Work Order ID 95841

Item Name: Pedal Bracket

DART AEROSPACE LTD	Work Order:	95841
Description: Pedal Bracket	Part Number:	D3205-1
Inspection Dwg: D3205 Rev: B		Page 1 of 1

**From:** Jean-Luc Menard [<mailto:jmenard@dartaero.com>]  
**Sent:** Tuesday, July 24, 2012 8:41 AM  
**To:** Marc.Bellavance  
**Cc:** David Shepherd; L Lacelle  
**Subject:** D3205-1 Bracket PAR

D3205-1 PEDAL BRACKET

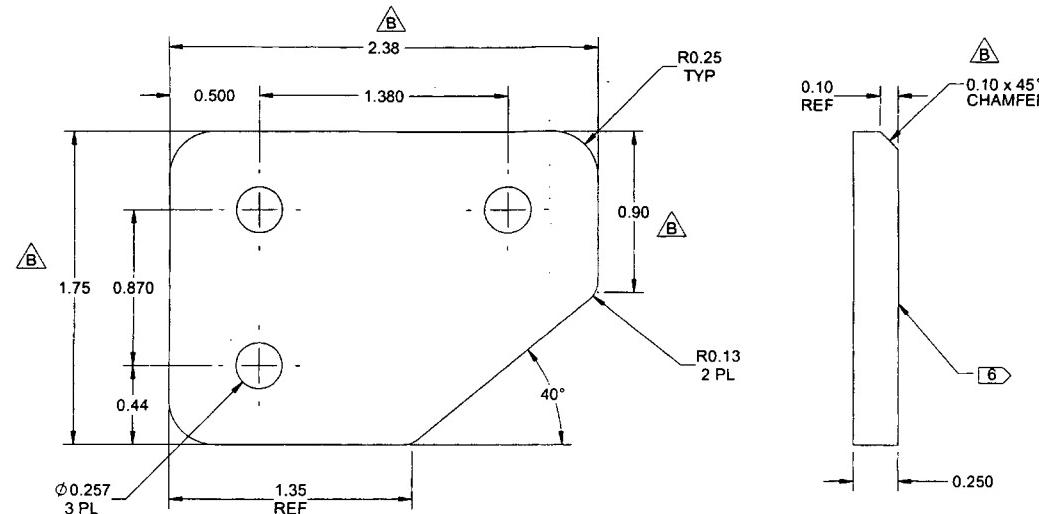
On the d3205 dwg there was a grain direction added on the last rev, I spoke to David last night and he agrees that we should remove it as the material used for this part is 7075-t73 3.25" x 2.5" bar.

This Bar is also used for the D2224 rappel anchor, I don't think it's a good idea to have two bars with the same dimensions and only the grain separating the two.

So all that to say could you issue a par so we can get the grain direction changed on the d3205-1 pls.

PAR12-212 opened...
